**Site Characterization/Remedial Investigation Reports/Risk Assessments
Philadelphia Refinery Complex
3144 Passyunk Avenue, Philadelphia, Pennsylvania**

Written Comments by Clean Air Council

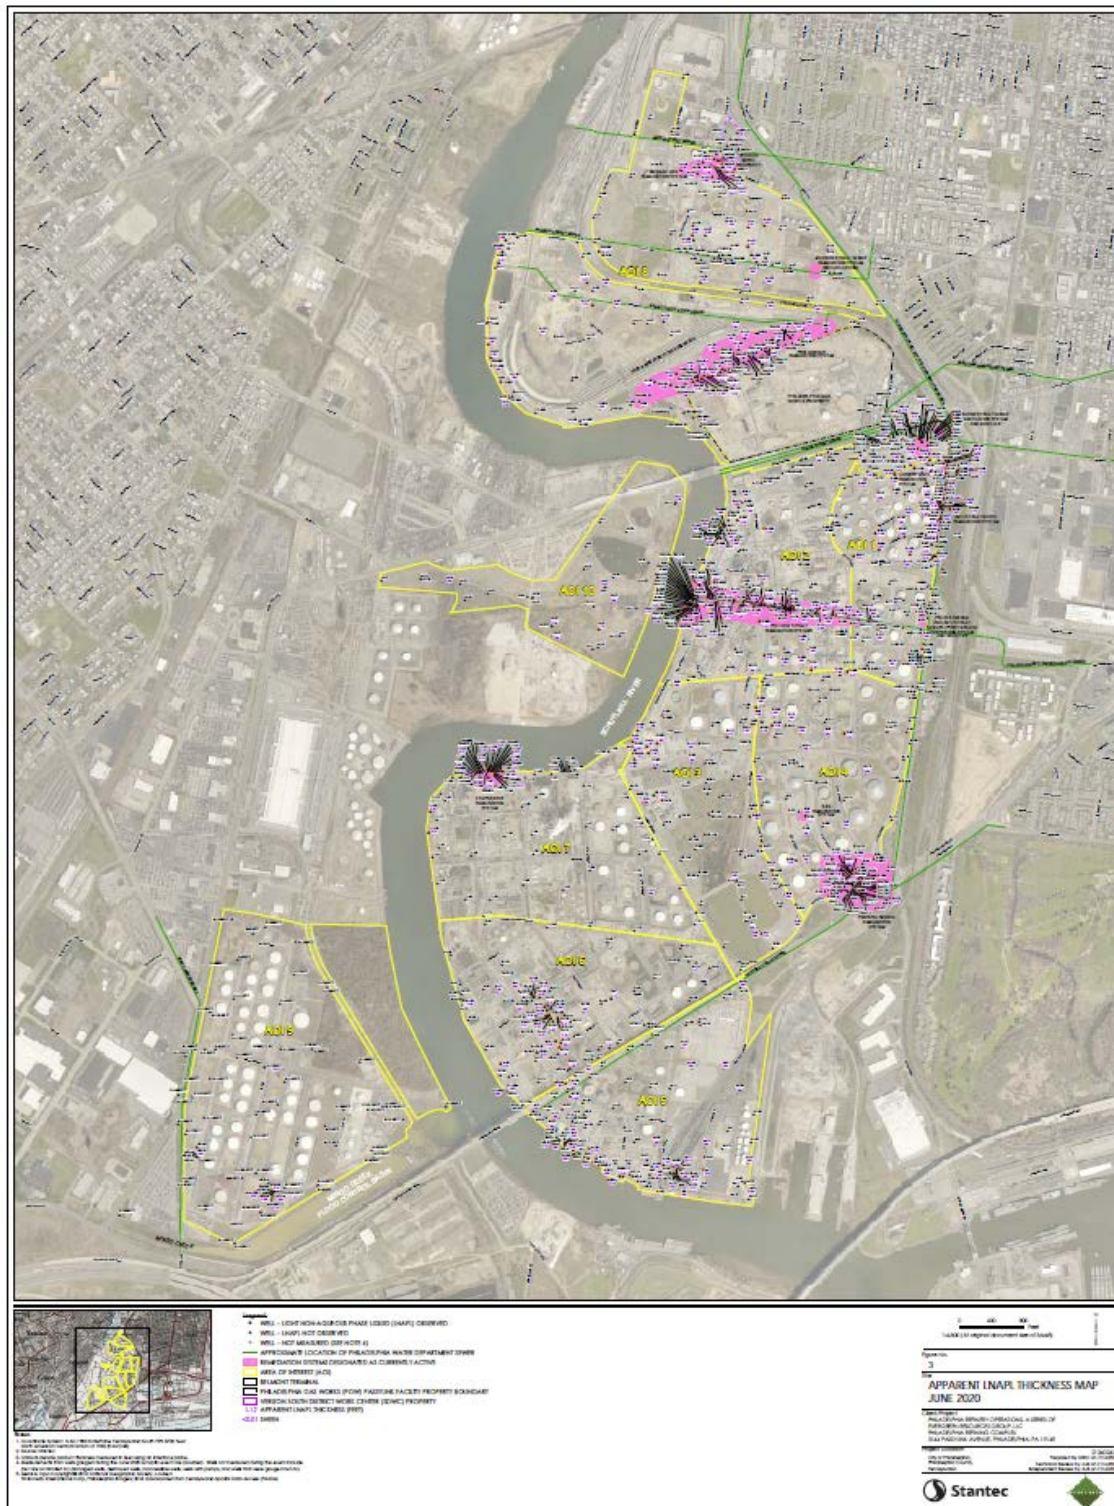
In addition, those reports provide a more precise delineation of Light Non-Aqueous Phase Liquids in shallow wells. Figure 3 in a recent groundwater remediation status report not only shows the presence of additional wells installed since 2017, but also demonstrates the apparent thickness of Light Non-Aqueous Phase Liquids:

See [Semi-Annual Remediation Status Report](#) (First Half 2020), Figure 3 (Apparent LNAPL Thickness Map), pdf page 14 of 52. These liquids were present in shallow wells S-414 (thickness of 1.50 feet), S-382 (thickness of 0.92 feet) and S-283 (thickness of 0.54 feet). In

contrast, the remedial investigation report for AOI-3 shows no Light Non-Aqueous Phase Liquids in these shallow wells. *See* [2017 Report](#) (AOI-3), Section 5.7 (LNAPL Characterization Results), pages 33-35, Figure 16 (Figure 16: Apparent LNAPL Thickness and Type), pdf page 173 of 760.

Presumably, Evergreen has the means to address this problem. Evergreen should synthesize the material from the groundwater remediation status reports prepared every six months since 2015. *See generally* Evergreen, [Semi-Annual Remediation Status Reports](#). Those reports contain more recent data on groundwater. It would be a challenge for the public to undertake an analysis of those reports and synthesize them with the remedial investigation reports. This is something that Evergreen can and should do.

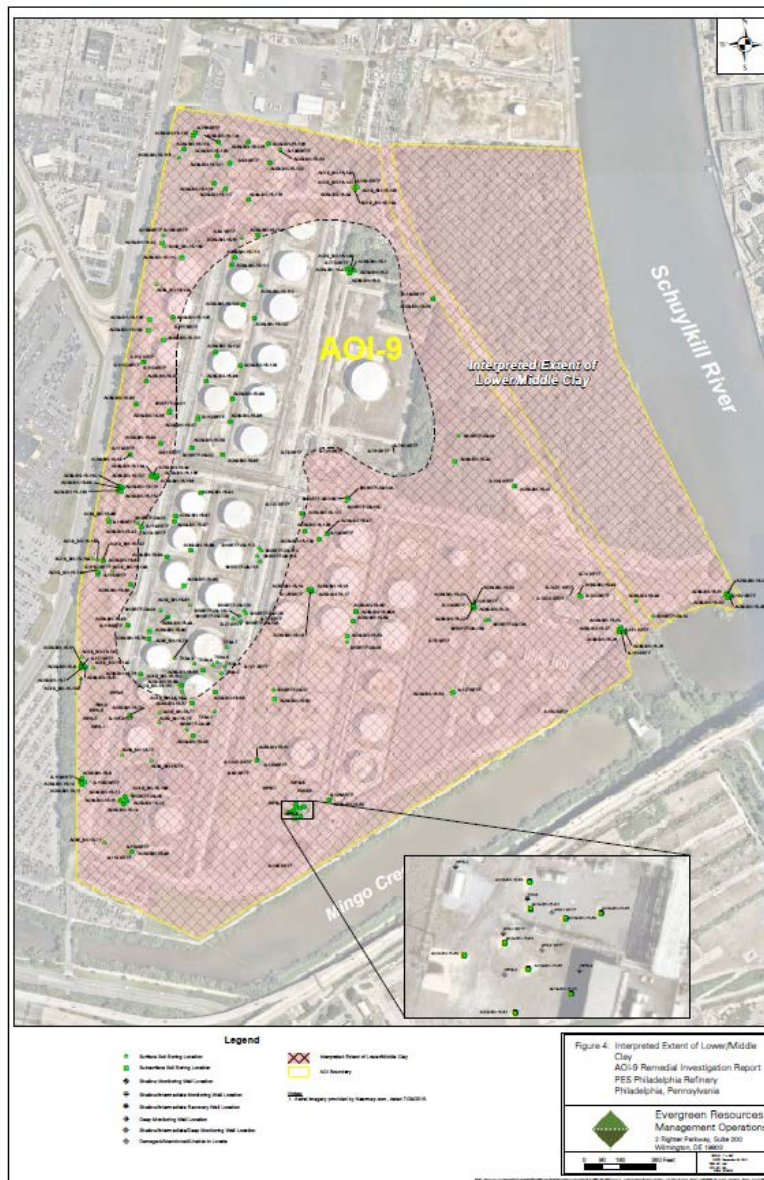
2. Why are there no downgradient property boundary wells at AOI 9 (i.e., along the western edge, see Fig. 5)?

There are clearly potential storage tank and pipeline sources in the area between the existing deep monitoring wells and the property line. ***The Middle Clay is absent there.*** Has Sunoco adequately determined conditions at the point of compliance?

See [2015 Report](#) (AOI-9), Figure 4 (Interpreted Extent of Lower/Middle Clay); *see also id.*, Figures 4, 5, 7, 8, 9, 10.

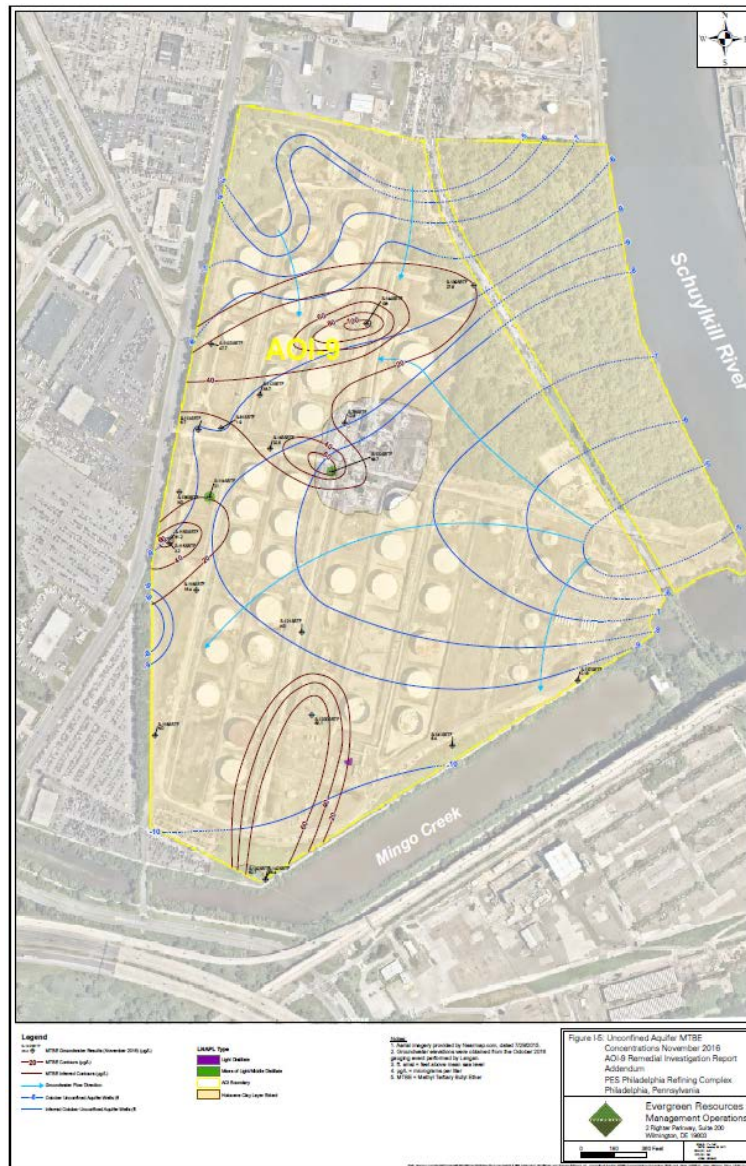
Apparently in response to the Department's comment on the report for AOI-11, Evergreen has attempted to map the extent of a shallow (not deep) perching clay unit shown in AOI-9 reports:

But Evergreen has not done this for the deep aquifer for AOI-9, and it has not done this for the other Areas of Interest. Evergreen should adopt a similar approach to mapping the extent of the clays for all Areas of Interest, for both shallow and deep units.

See [2017 Report](#) (AOI-2), Figure 6 (Cross Section B-B'), pdf page 206 of 215; see also *id.*,

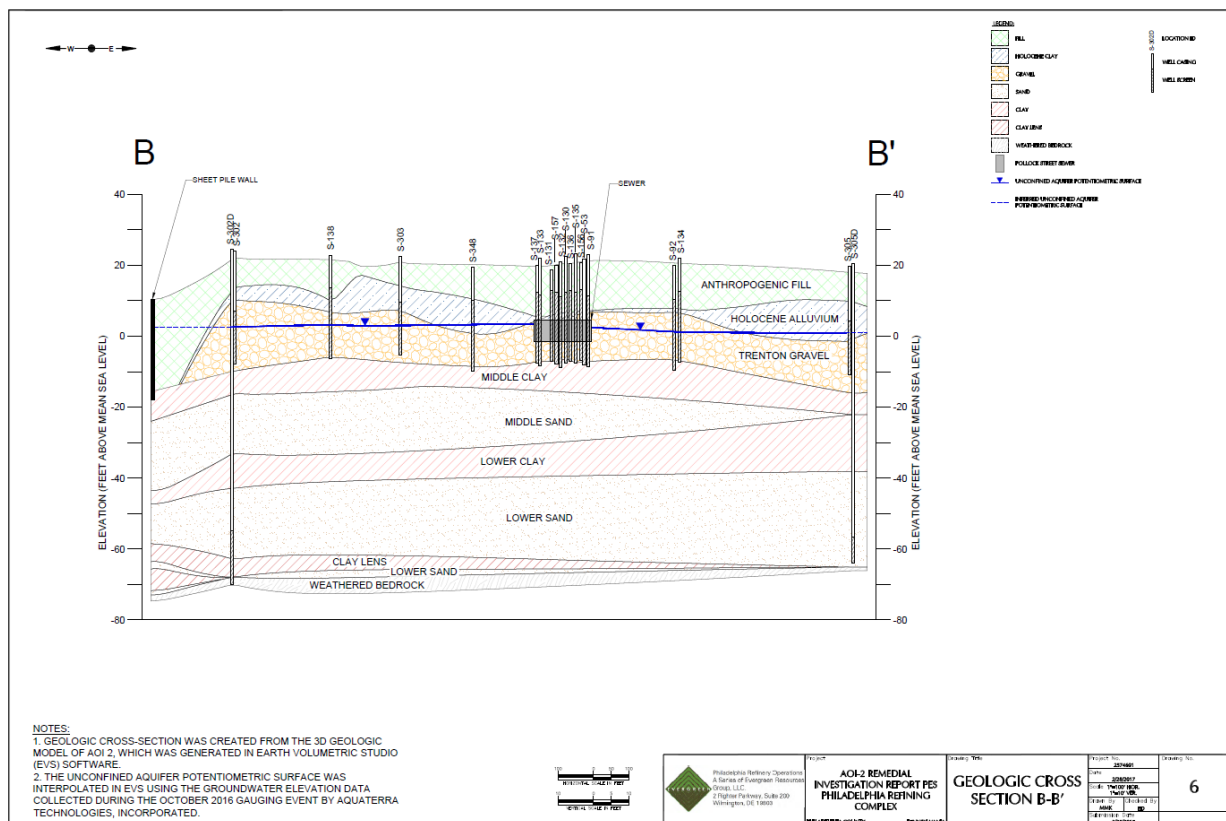
A geologic cross section for AOI-2 provides some information regarding the relative position of the sheet pile wall:

Figure 4 (Geologic Cross Section Location Plan), Figure 5 (Cross Section A-A'), According to the Figure above, the sheet pile appears to be lie even with the surface of the ground, and appears to have a depth of about 28 feet, extending into the clay by one or two feet. *See id.* Because the sheet pile wall appears to lie right on the Schuylkill River, Evergreen has an obligation to delineate whether contaminated groundwater is migrating into the river.

See [2017 Report](#) (AOI-2), Figure 12A (Summary of Unconfined Aquifer Groundwater Sample Exceedances), pdf page 212 of 215.

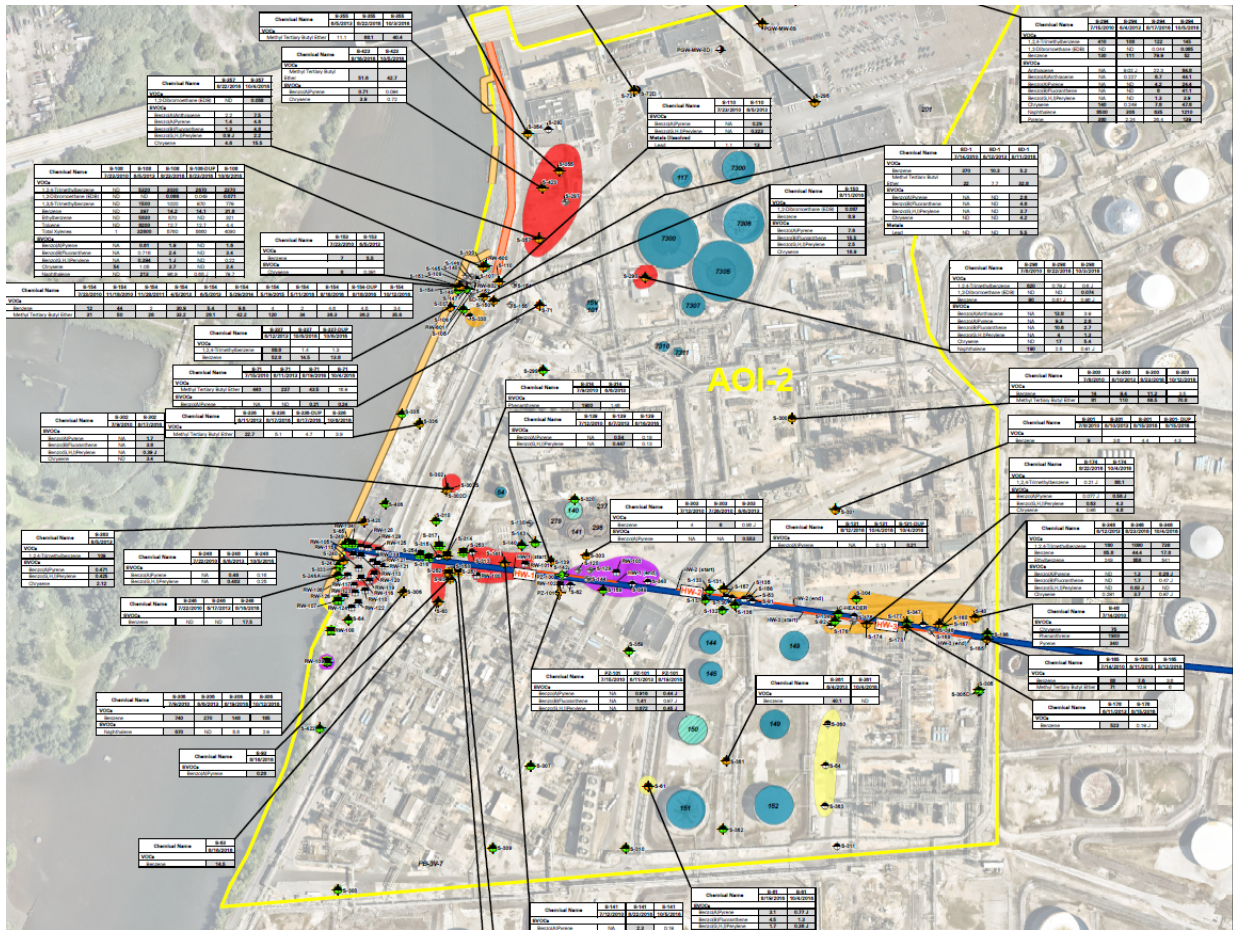
The following screenshots illustrate some of this contamination:

[2017 Report](#) (AOI-5), Figure 4 (Geologic Cross Section Location Plan).

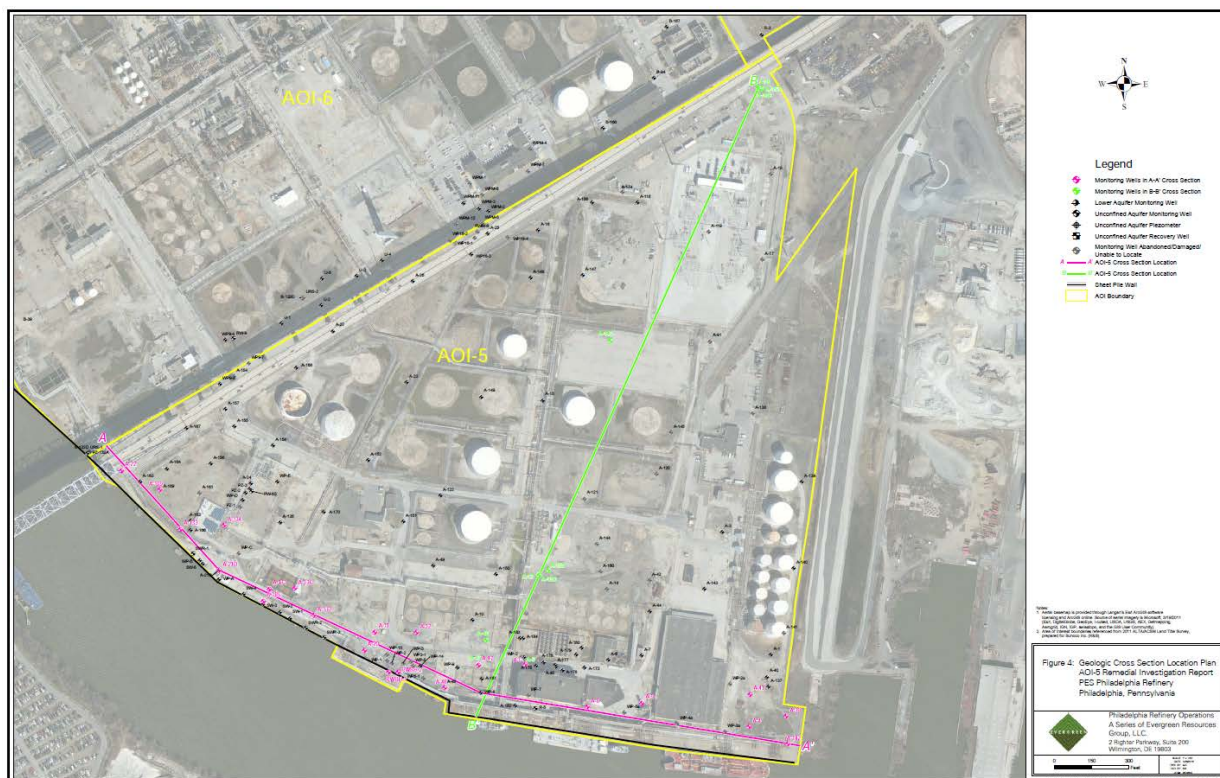
Instead, one must look to other evidence to ascertain the depth to the water table from the surface. Evergreen has provided geologic cross sections for all Areas of Interest. To illustrate with respect to AOI-5, the following Figure from the 2017 report identifies two cross sections -- an A-A' cross section generally running from west to east (in pink), and a B-B' cross section generally running from north to south (in green):

See *id.*, Figure 5A: Geologic Cross Section A-A'.

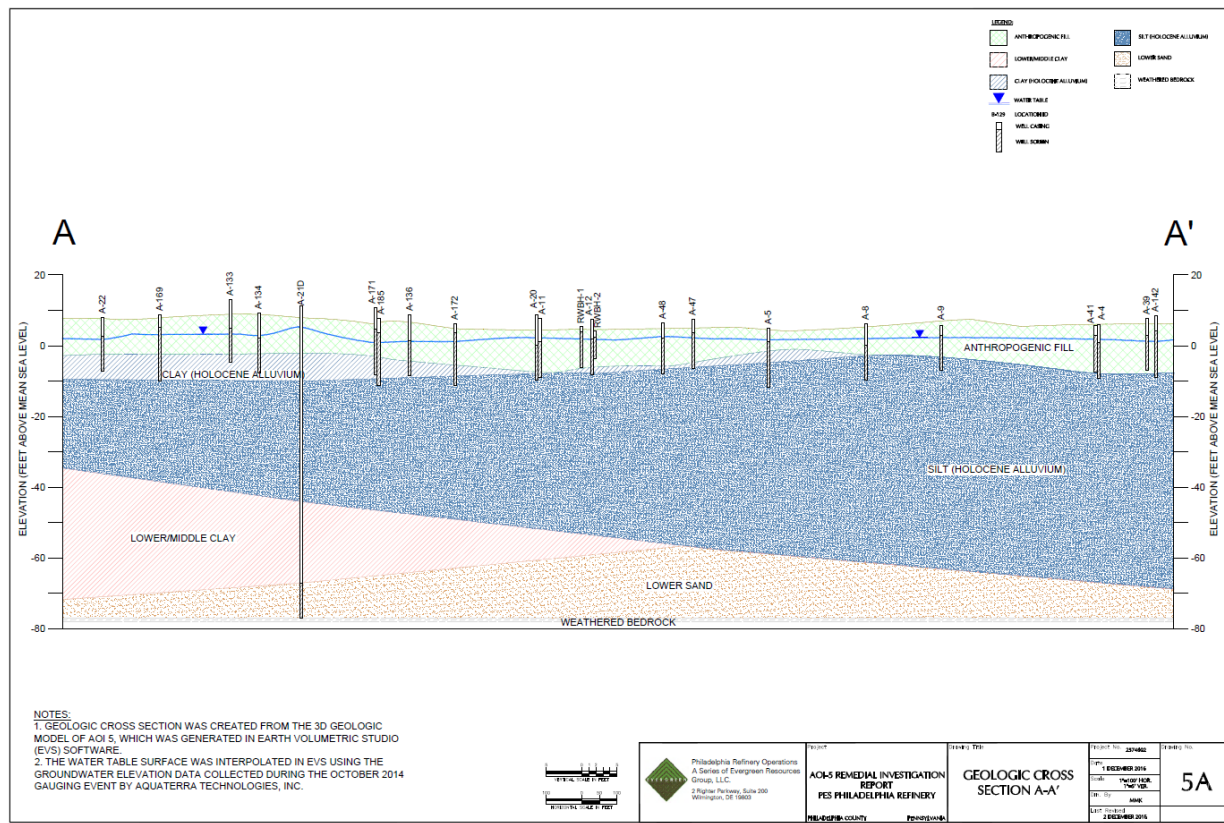
The following Figure displays a side view of cross section A-A', looking from the south toward the north. Throughout all of this cross section, the distance between the yellow line at the top (the surface) and the blue line below (the water table) is less than ten feet:

See *id.*, Figure 5B: Geologic Cross Section B-B'.

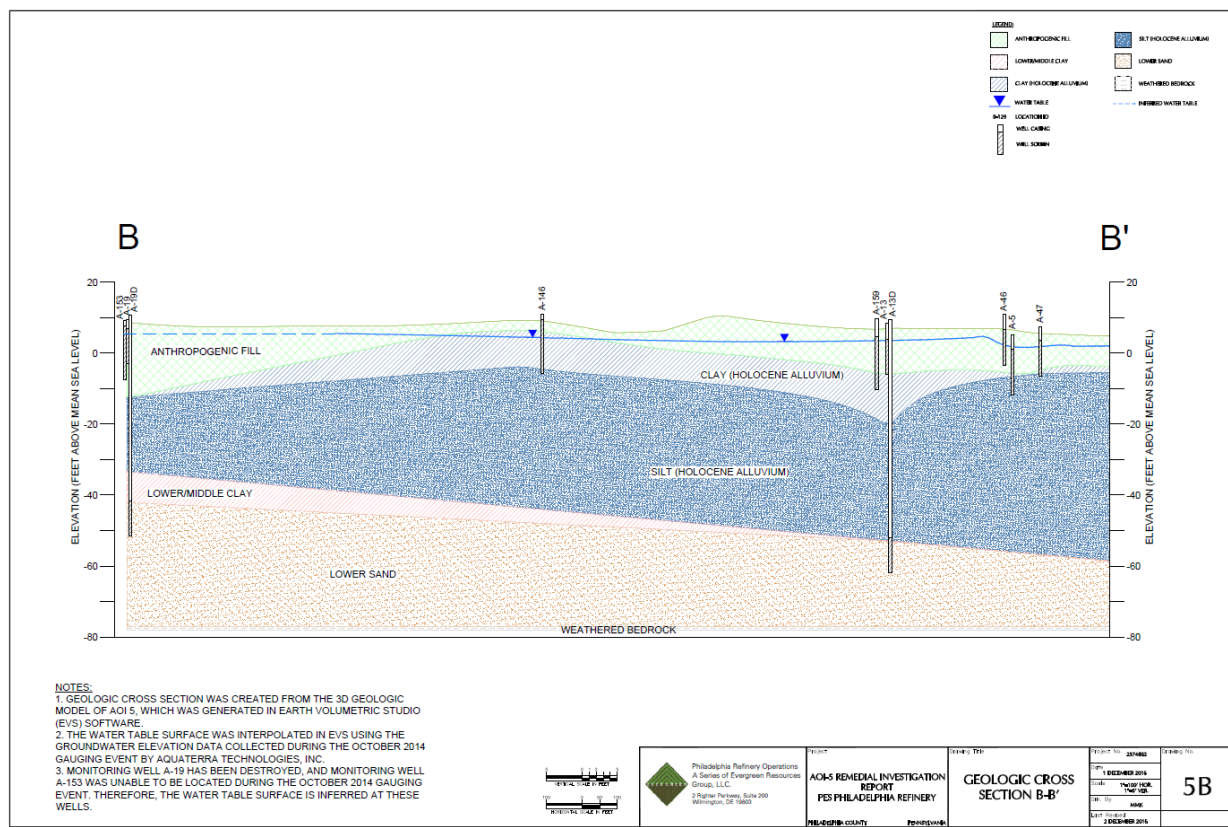
The other cross section B-B' tells a similar story. The following Figure displays a side view of this cross section, looking from the west toward the east. Throughout all the cross section, the distance between the yellow line at the top (the surface) and the blue line below (the water table) is less than ten feet:
